CIRCLE SQUARE PLOTS 2, 3 + 4
(FORMERLY KNOWN AS BBC SITE)
OXFORD ROAD, MANCHESTER

Non-Material Amendments
April 2020

4.4 Stage 5 (Current) Drawing - Level 6

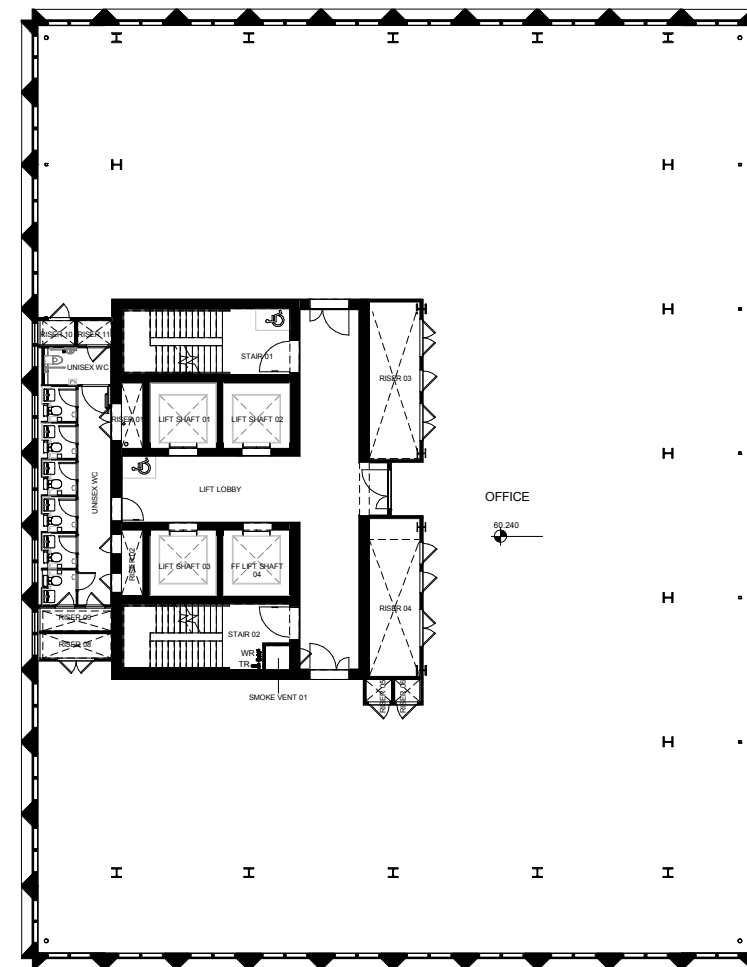
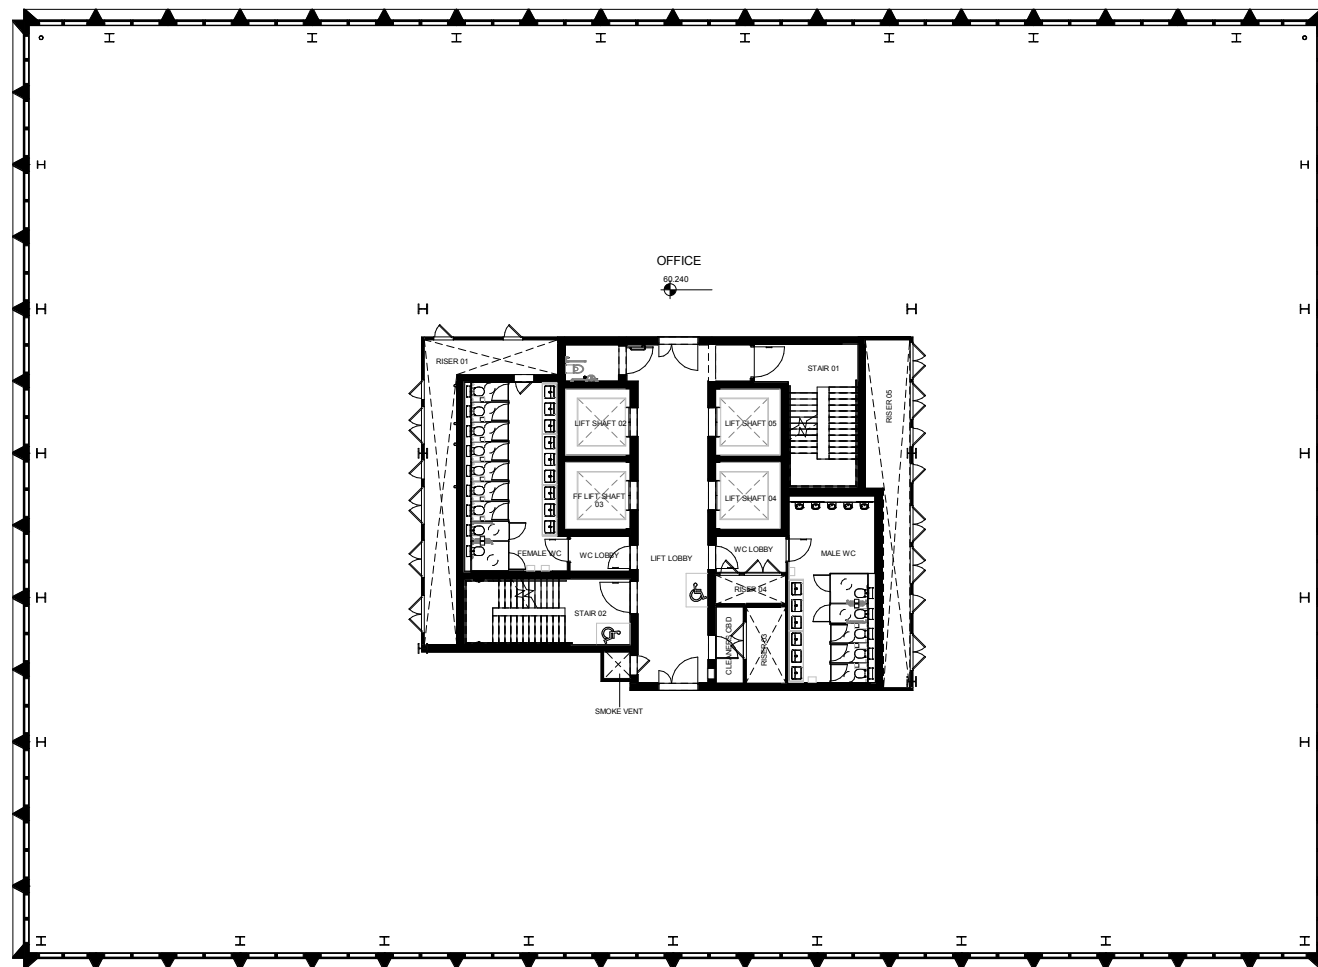
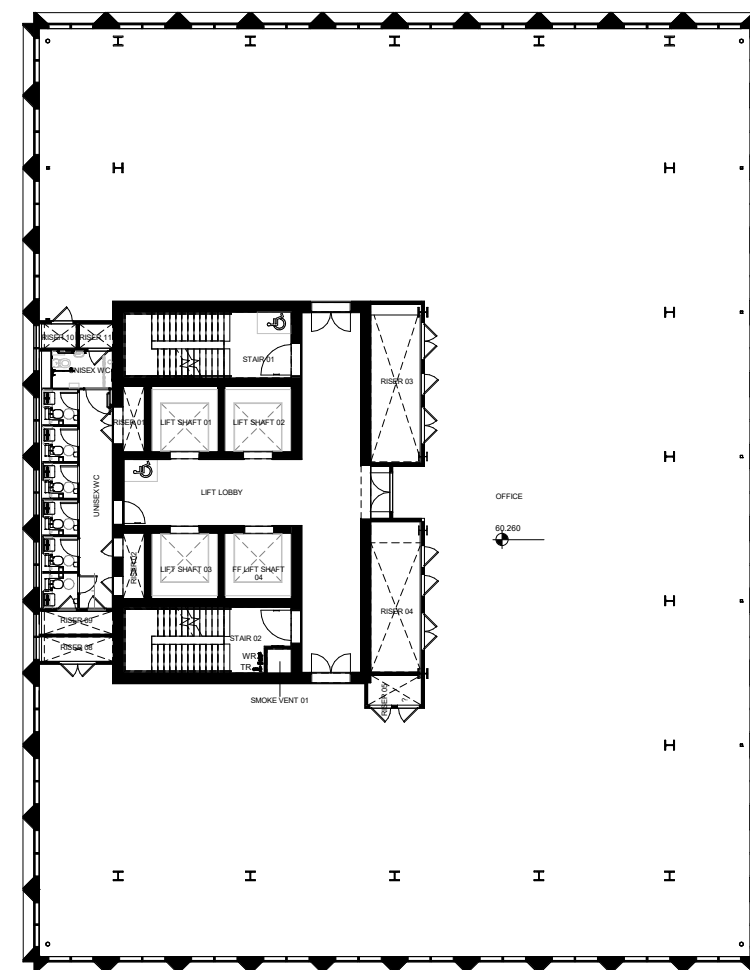
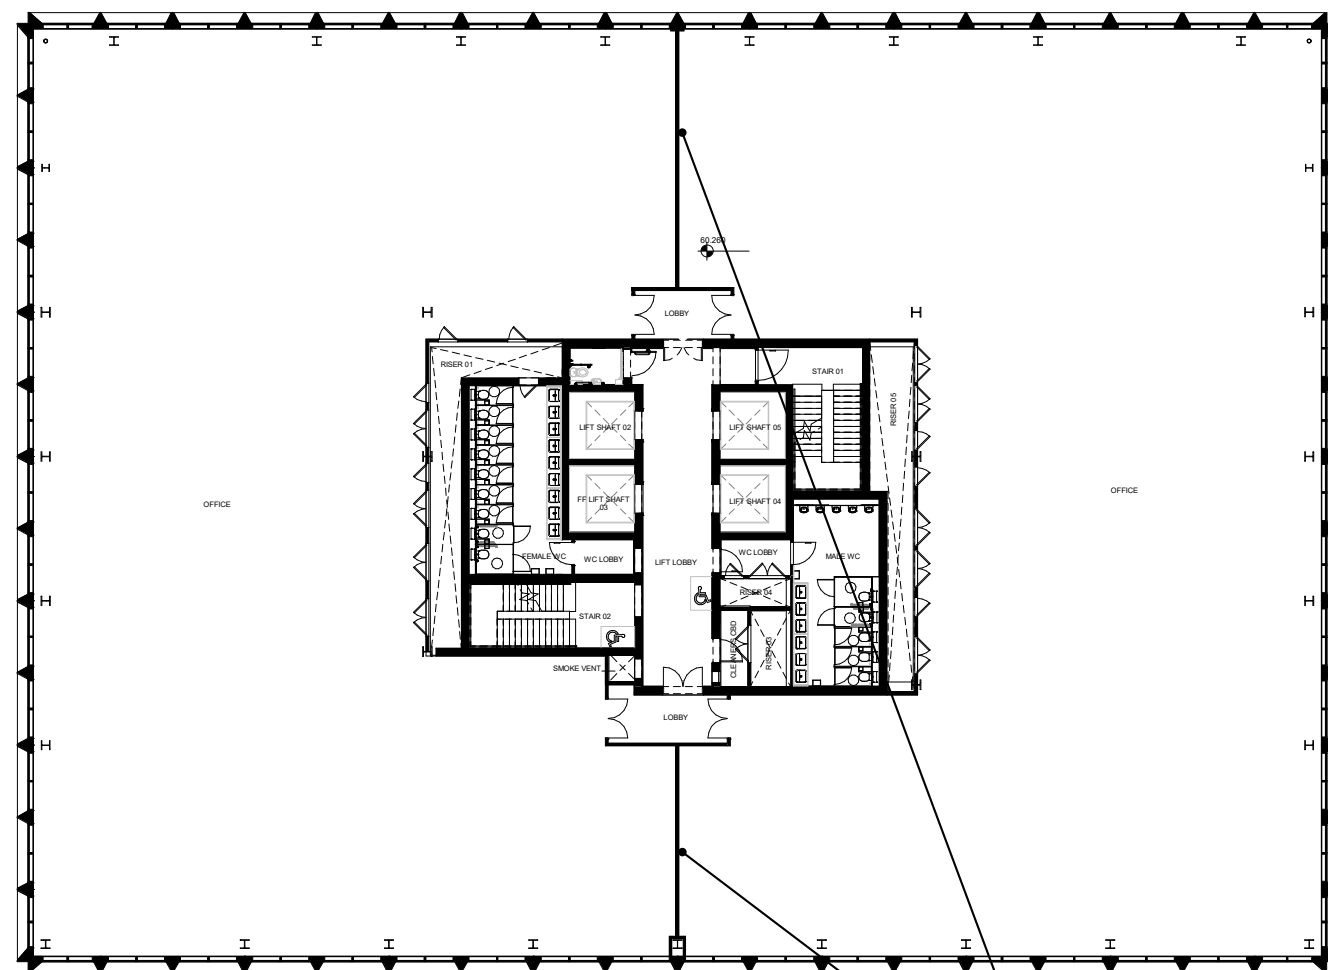
To help accomodate future users the floorplates on these two levels have been subdivided to meet tenant requirements.

Floorplate subdivision added

5.1 Fascia height - Elevations

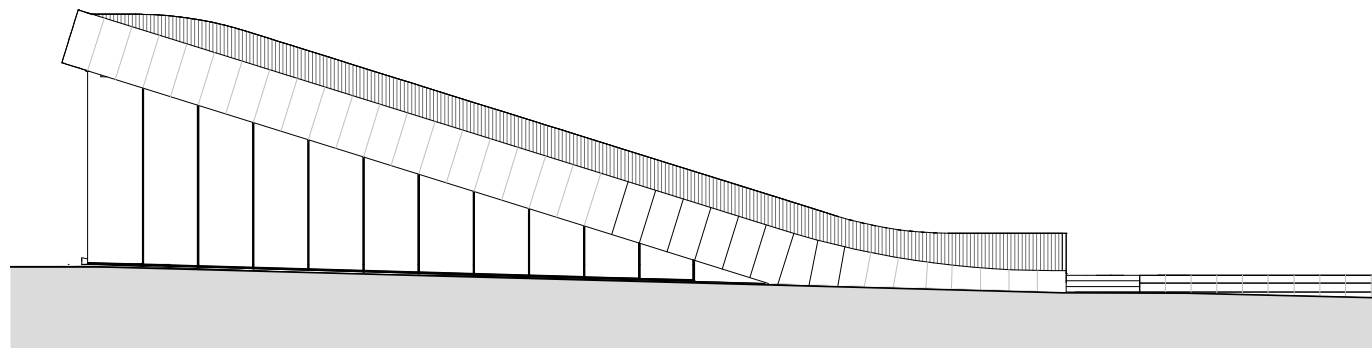
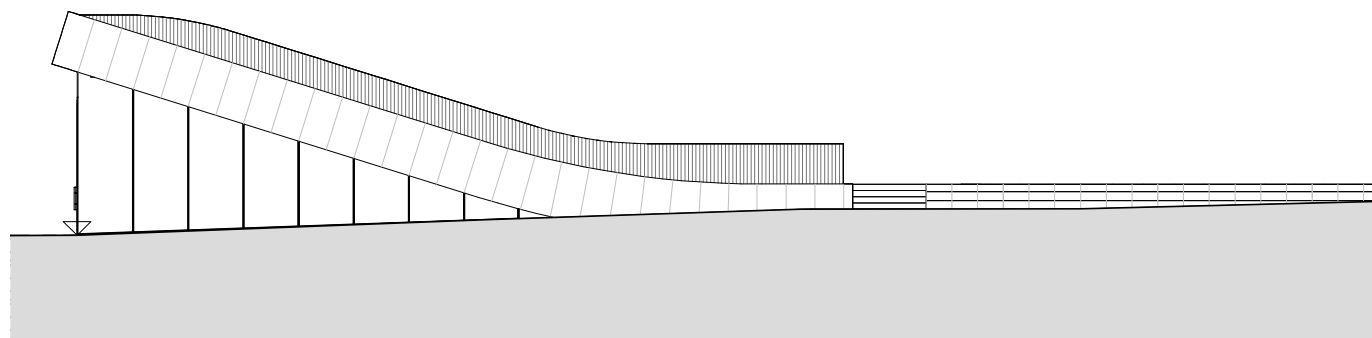
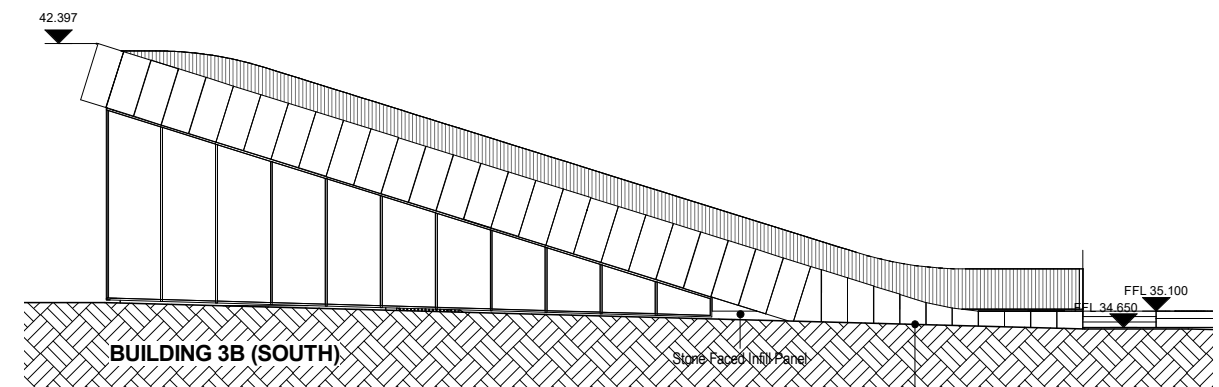
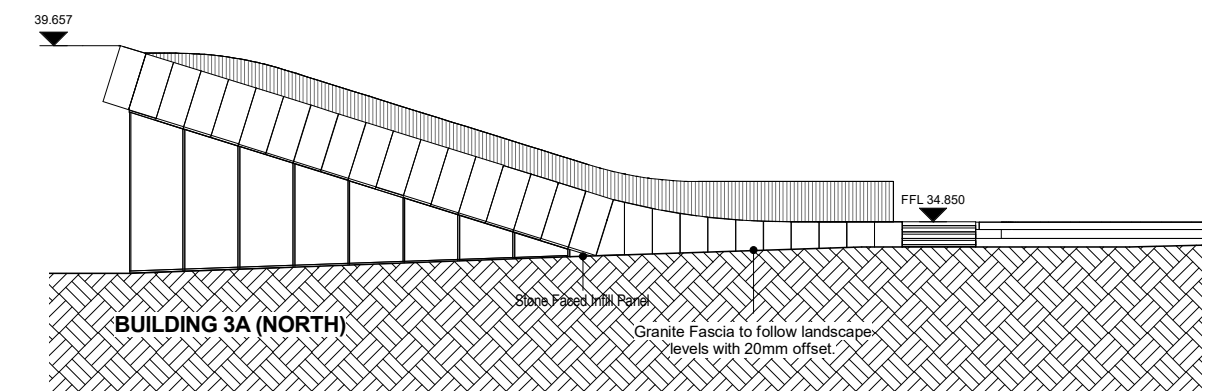
Further to detailed development of the stone fascia around the rim of the pavillions, the overall height has slightly increased.

Building 3A
Approved Planning Design, Fascia top spot height: **42.316**
(East Elevation)

Building 3B
Approved Planning Design, Fascia top spot height: **39.546**
(West Elevation)

Building 3A
Stage 5 Design, Fascia top spot height: **42.397**
(East Elevation)

Building 3B
Stage 5 Design, Fascia top spot height: **39.657**
(West Elevation)

5.2 Soffit material - Detail

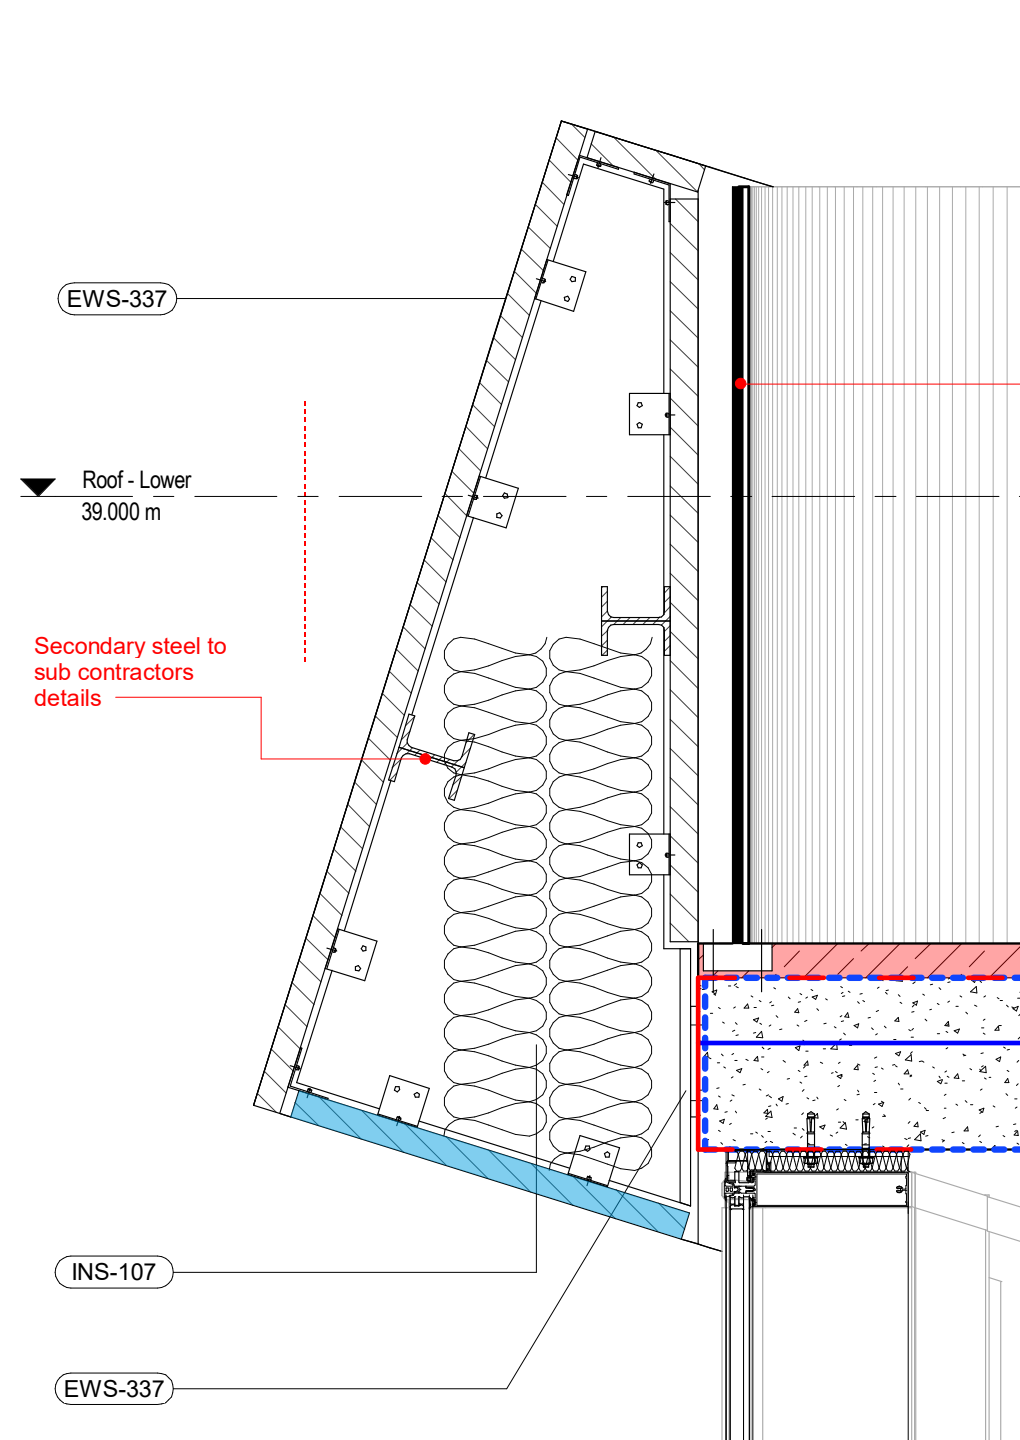
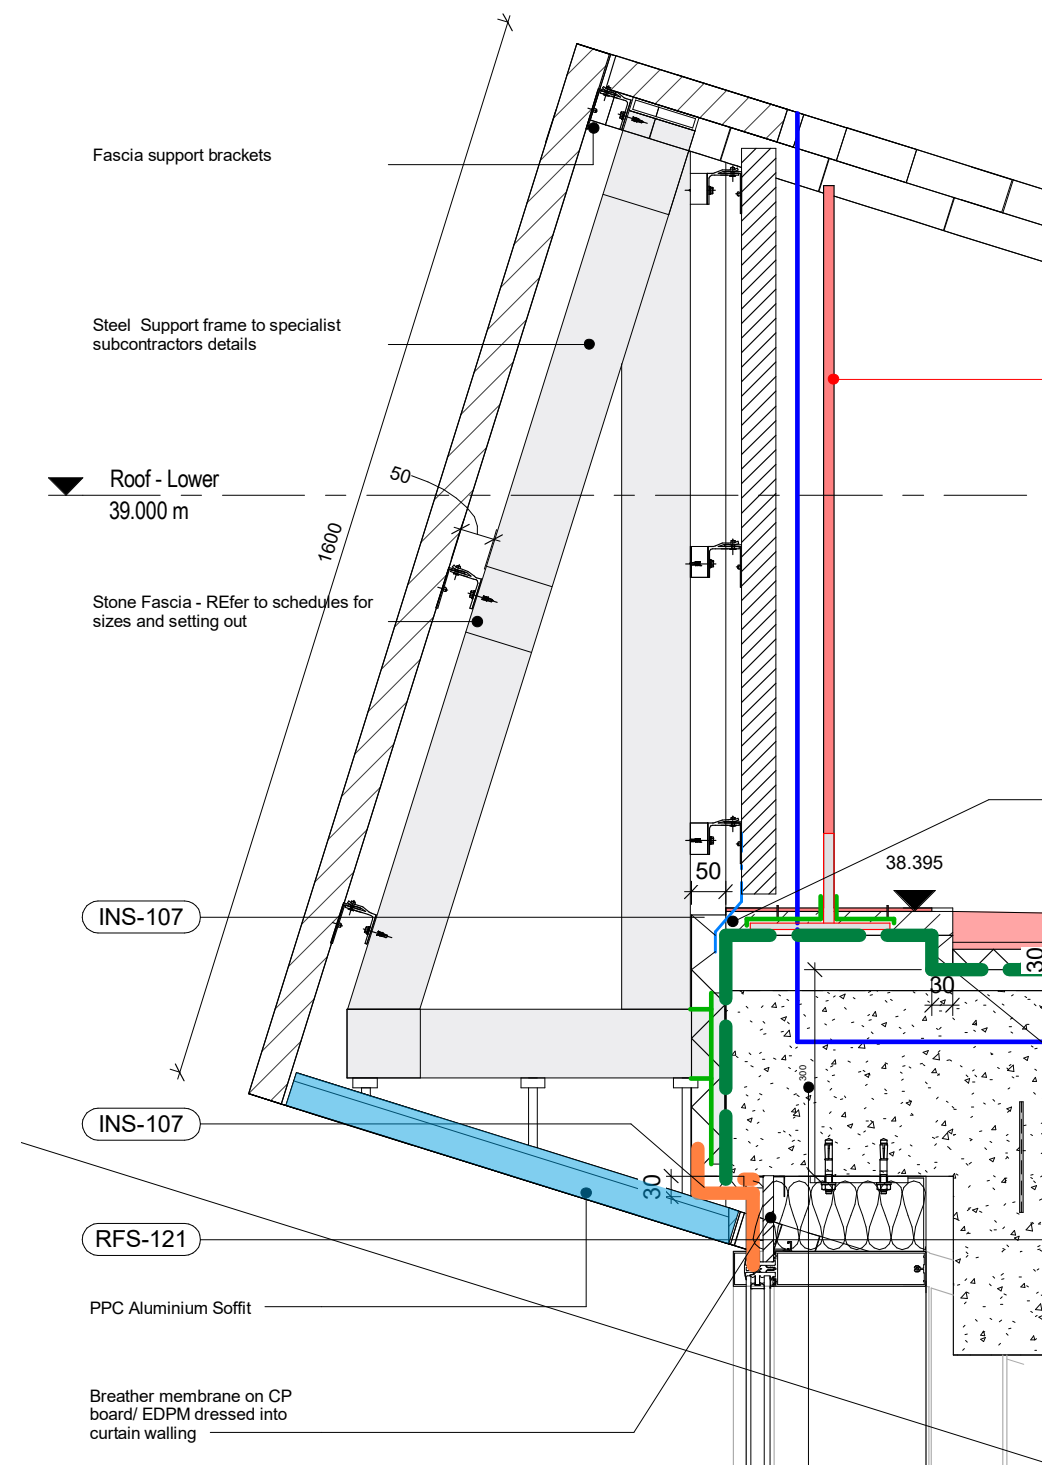
In addition to the note above, the soffit material has changed from stone to PPC steel following maintenance and quality considerations given the exposed location of the panels.

Approved Planning Design, Fascia Detail
(Stone soffit)

Stage 5 Design, Fascia Detail
(PPC aluminium soffit)

5.3 Staircase redesign - Ground floor plan

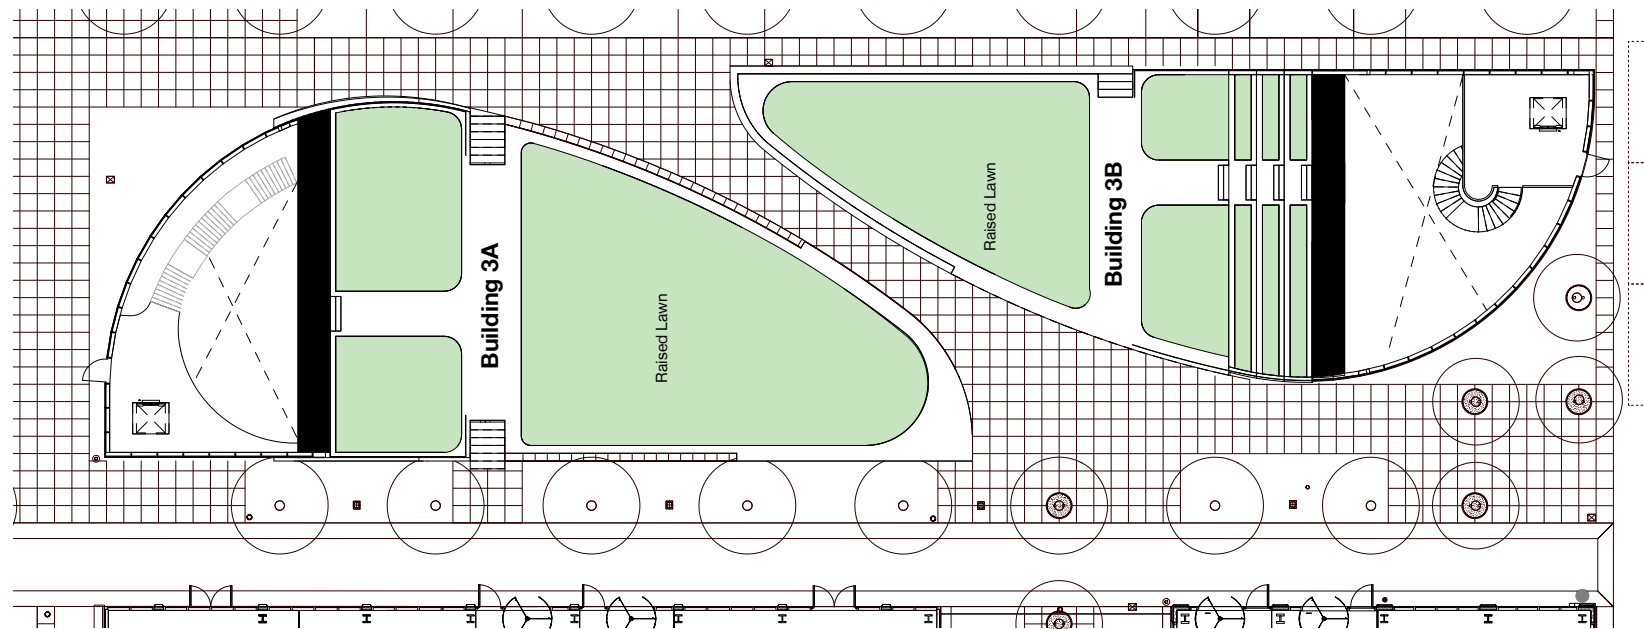
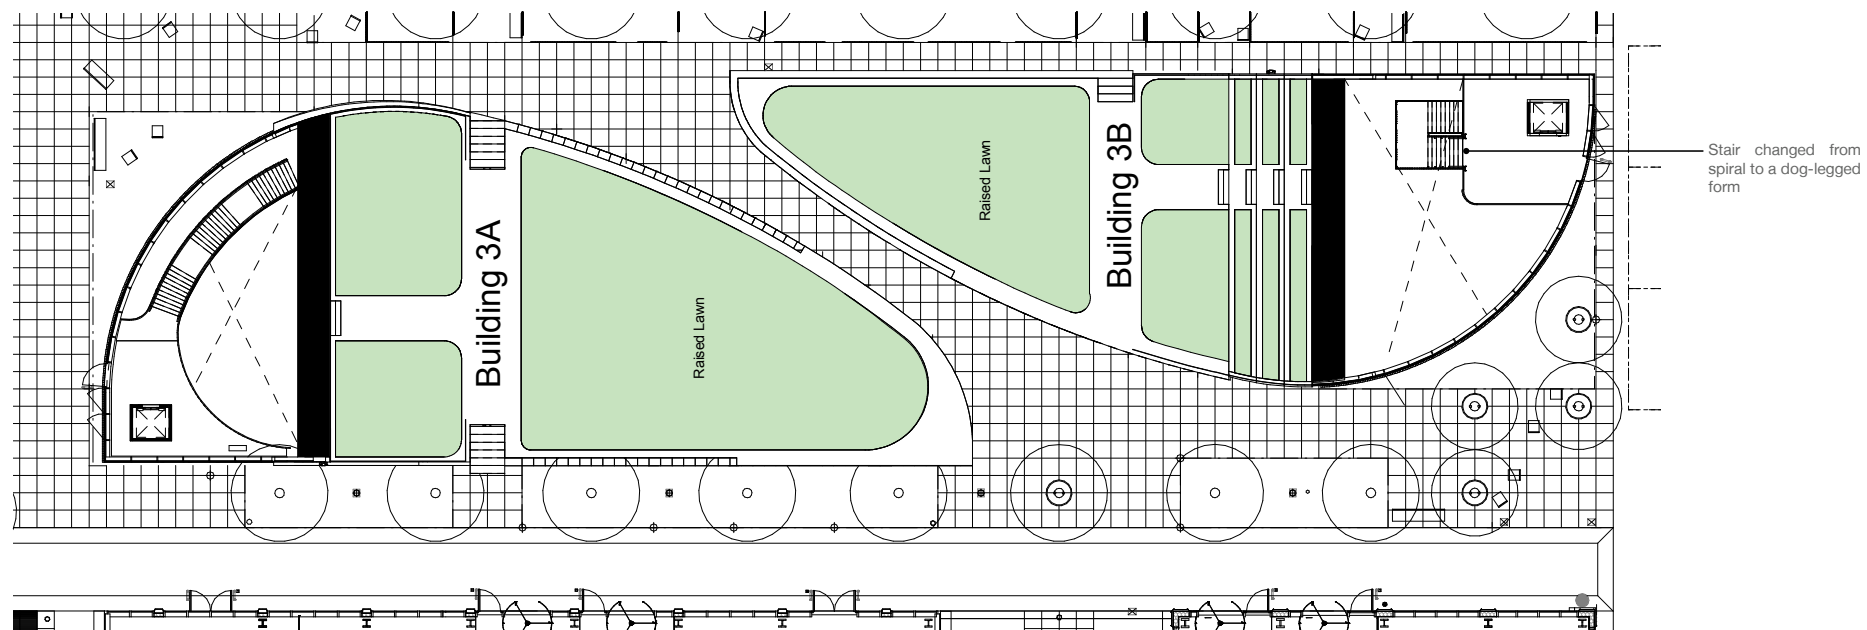
The stairs in Building 3B changed from a circular to a dog-legged form.
